**CITY OF WEST DES MOINES  
PLAN AND ZONING COMMISSION COMMUNICATION**

**Item:** Union 315 Mixed Use, 309, 313, and 315 5<sup>th</sup> Street – Approval of a Site Plan to allow construction of a mixed-use building – Taxium, LLC – SP-004778-2020

**Requested Action:** Recommend Approval of Site Plan

| SHEET NUMBER:<br>C2.1   |

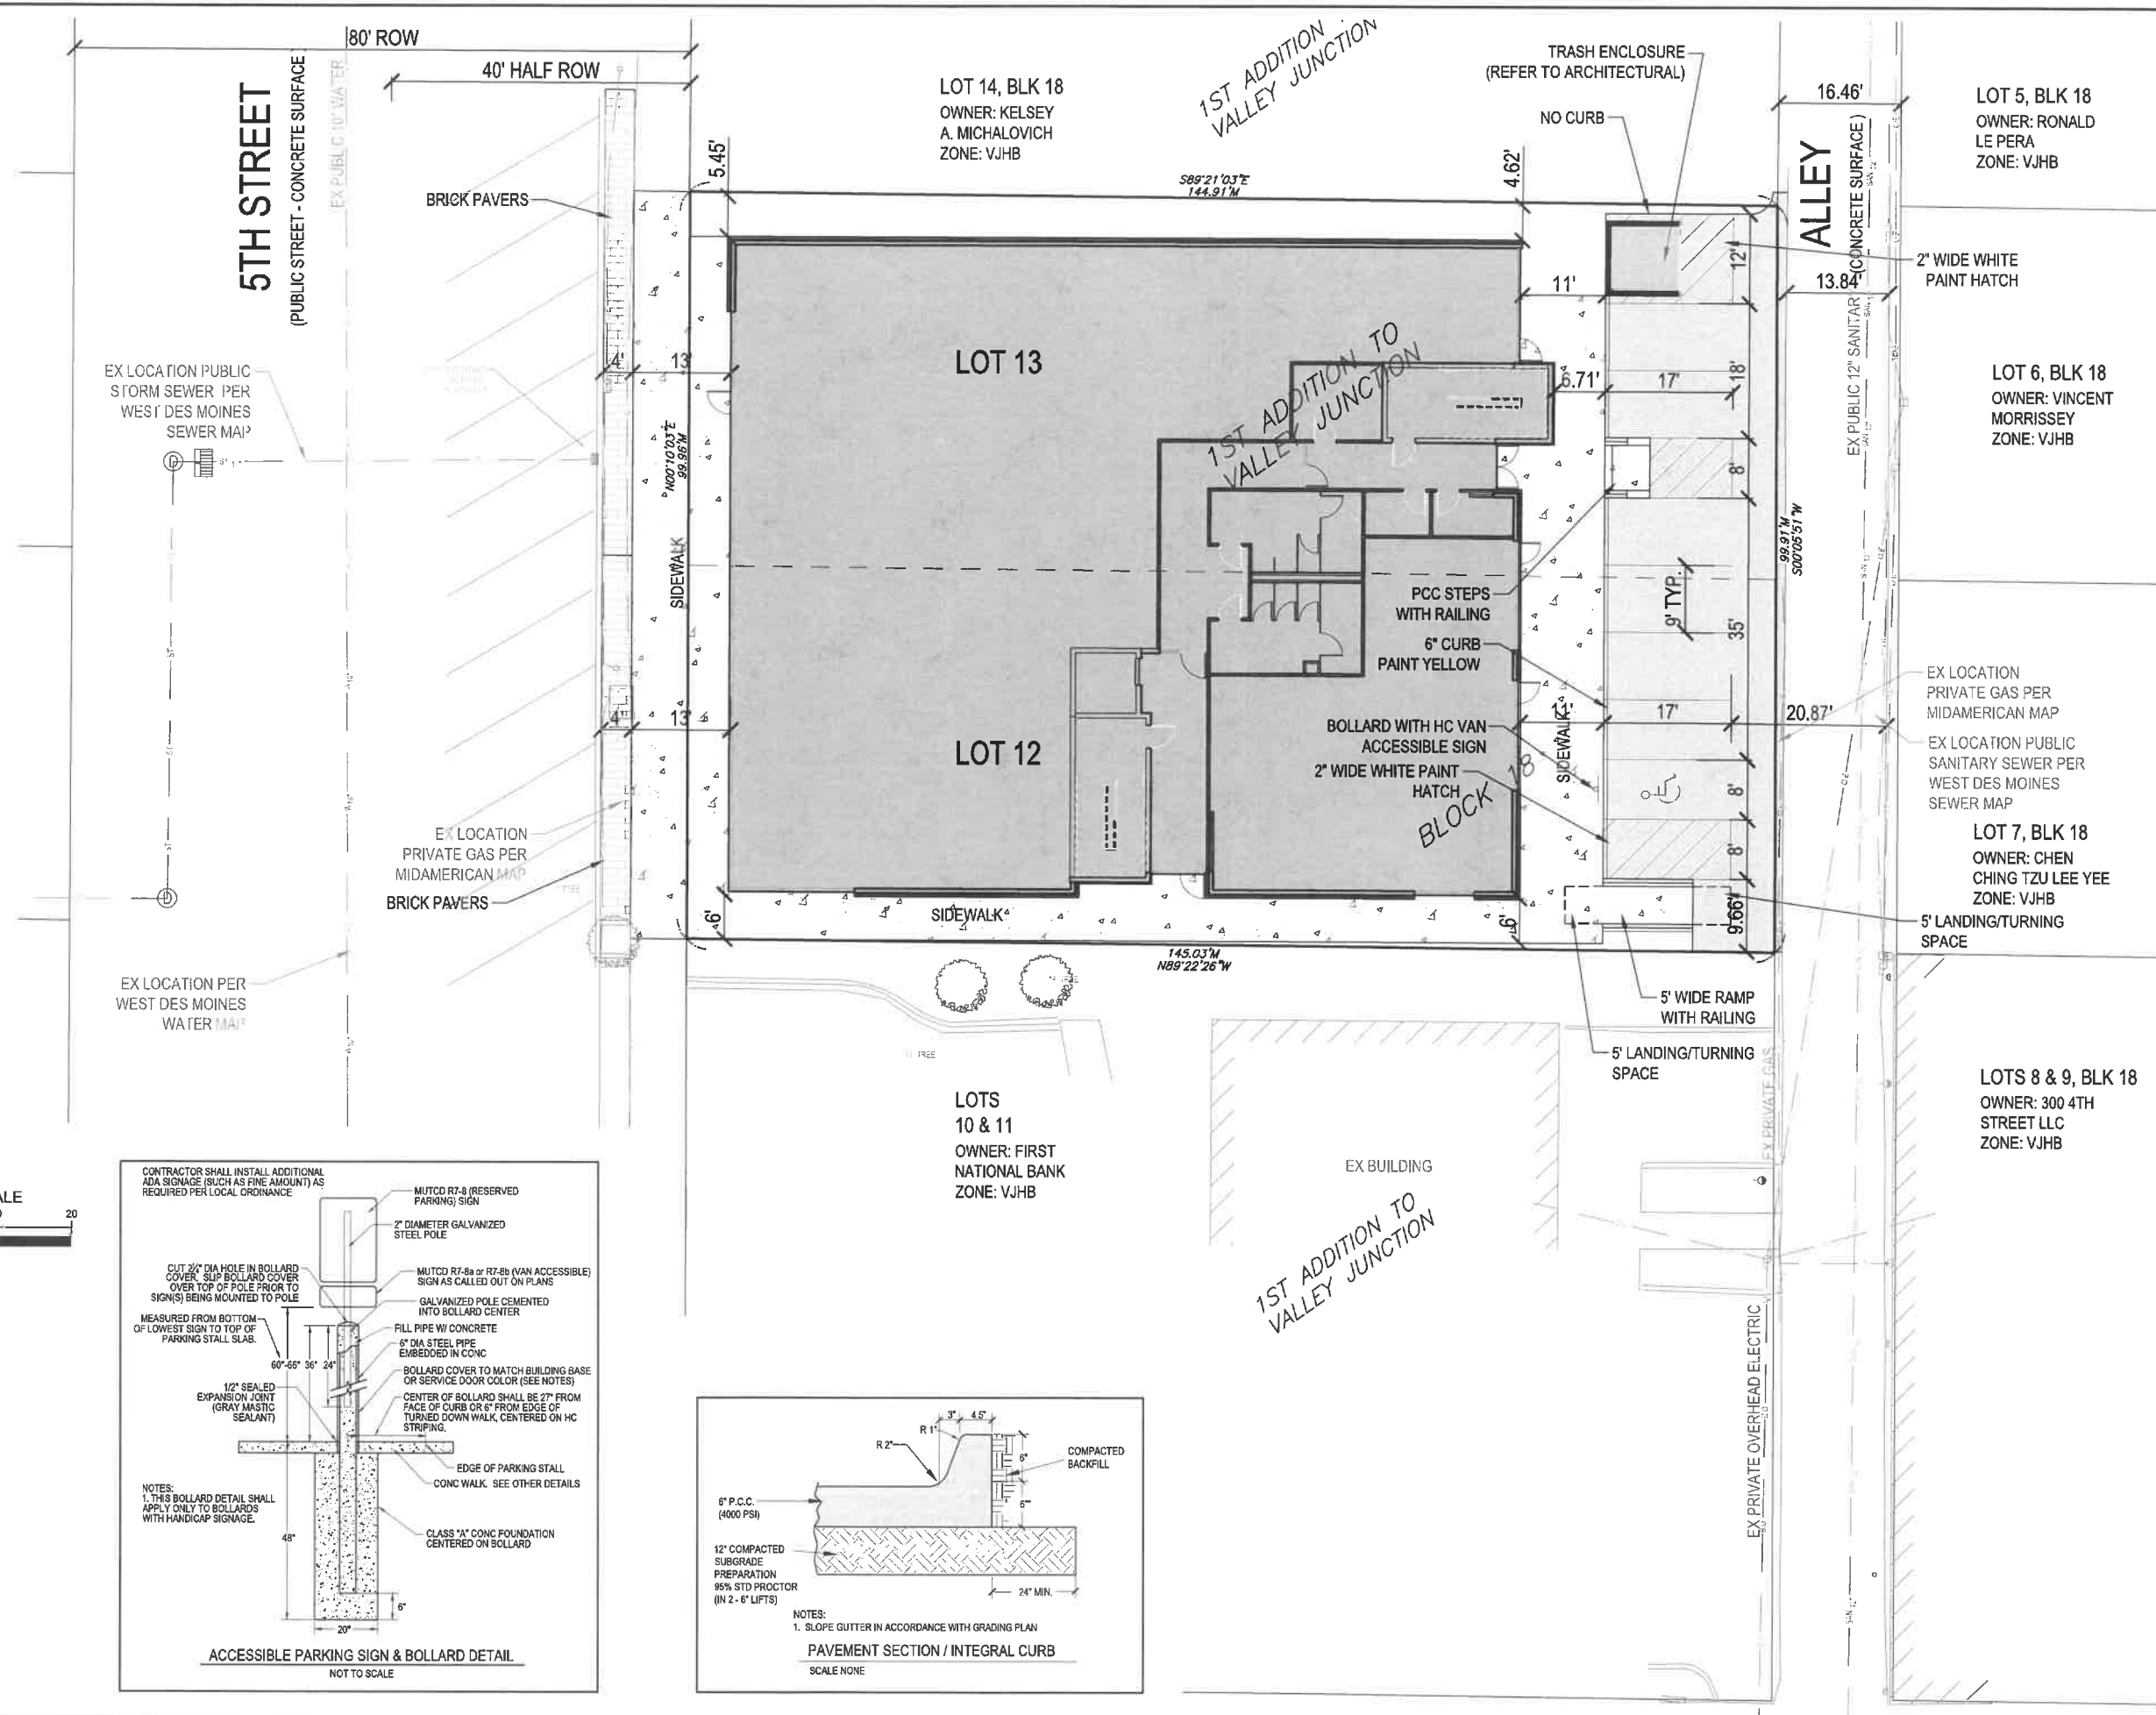
- **Meter Bank Area Screening.** The site plan shows these meter areas to be located near the northeast corner of the proposed building. While the zoning code requires these features to be screened, there is an existing structure north of the subject property that provides sufficient screening. Therefore, staff is recommending a Condition of Approval that in such time when the building to north is demolished the property owner will provide sufficient screening of the meter bank area.
